## PEER REVIEW

**TO:** Town of West Tisbury Conservation Commission  
**FROM:** Stan Humphries @ ECR *SMH*  
**DATE:** August 7, 2023  
**LOCUS:** 245, 257 and 271 John Cottle Rd., West Tisbury

**Figure 3. Recommended Alternative Analysis 6** to minimize project impacts. The different colors correspond to those used on the Sourati Plan for the different measures being proposed.

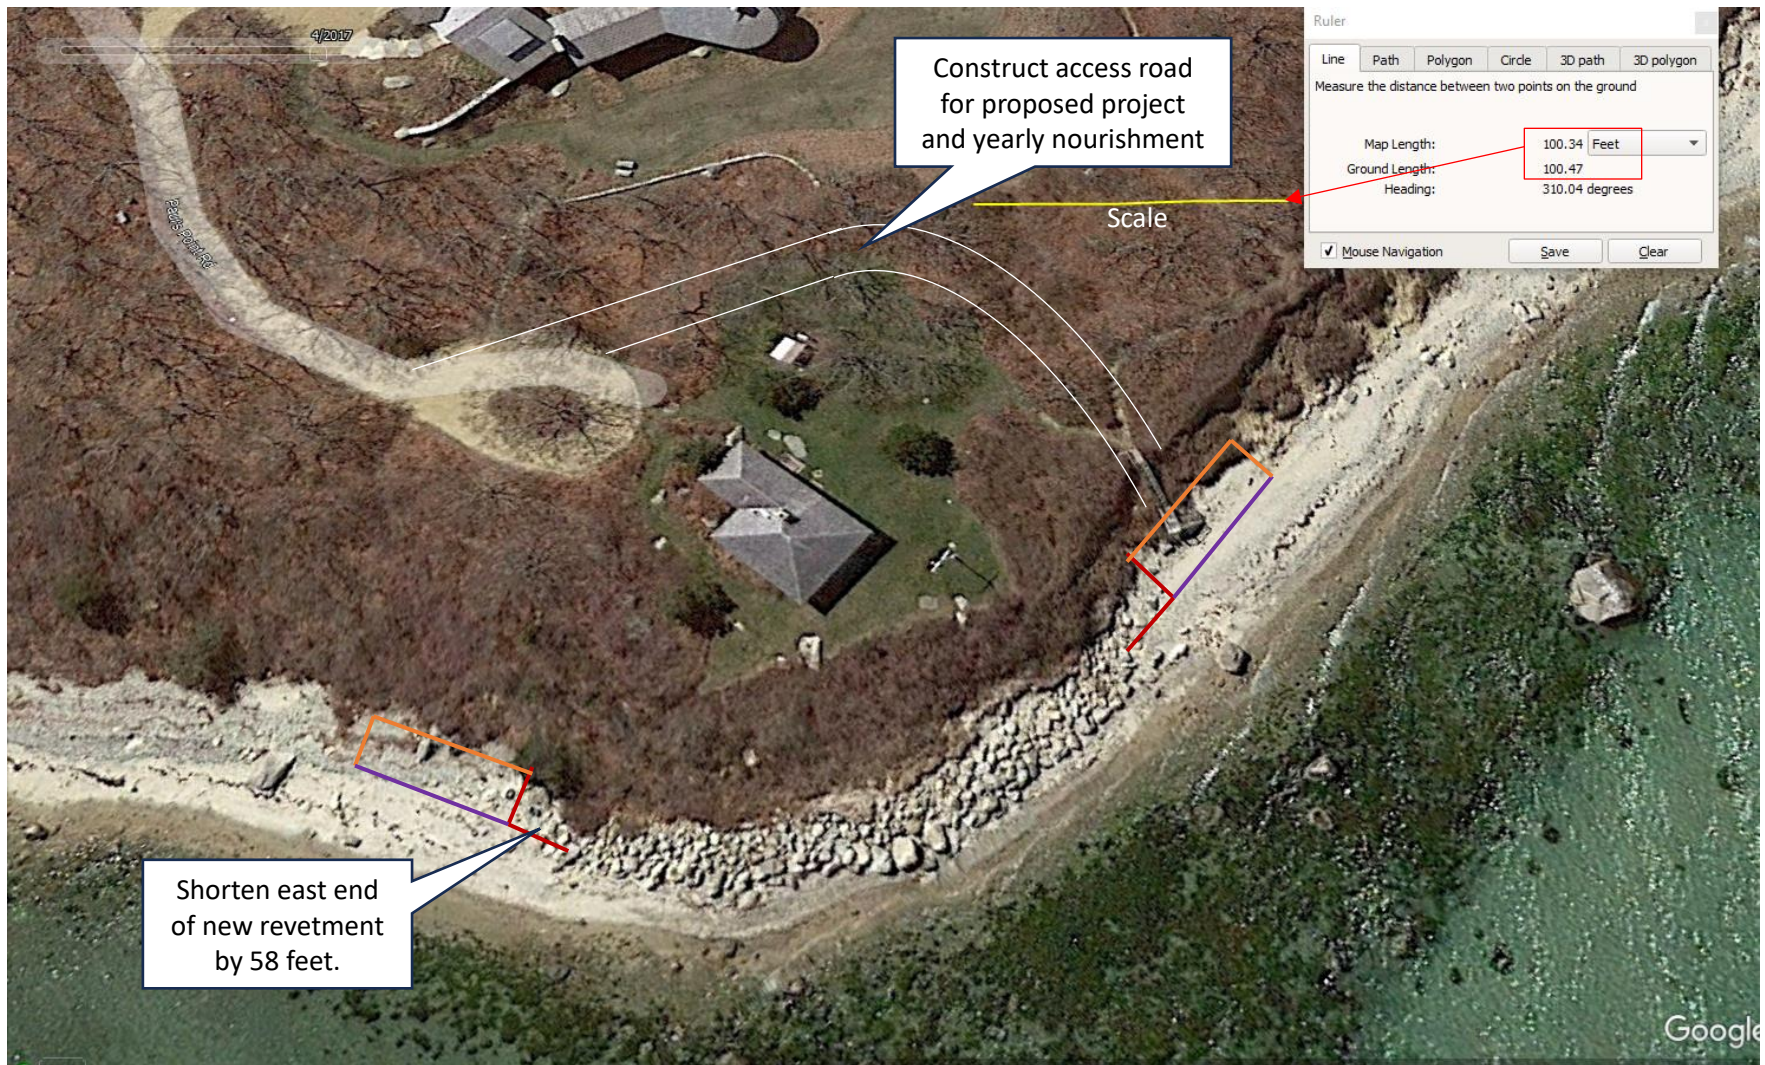
The Applicant has evaluated five (5) alternatives which address (b) of this section, but it is (a) of this section that requires more attention so as to minimize adverse effects. We recommend that a sixth alternative be evaluated as summarized in Figure 3 which would maintain the length and location of the protective measures on the west side, shorten and shift the measures westward on the east side, include tapering of the ends, and consider relocating the construction access within much closer proximity to the project. The current access proposal will have an adverse effect on the coastal dune and beach, initially, and presumed to have negative impacts in the future if it is used for annual nourishment.

The approximate 16' buffer from cottage to the top of the bank is likely close enough to be considered imminent danger and the proposed revetment reconstruction with other gabion/coir measures, to a large degree, may be permissible. However, in consideration of the difference in eroded conditions of the bank, the length of the revetment, and the proposed short- and long-term impacts to the coastal dune from construction access, there is another alternative (6) which would minimize adverse effects of this shoreline protection project.
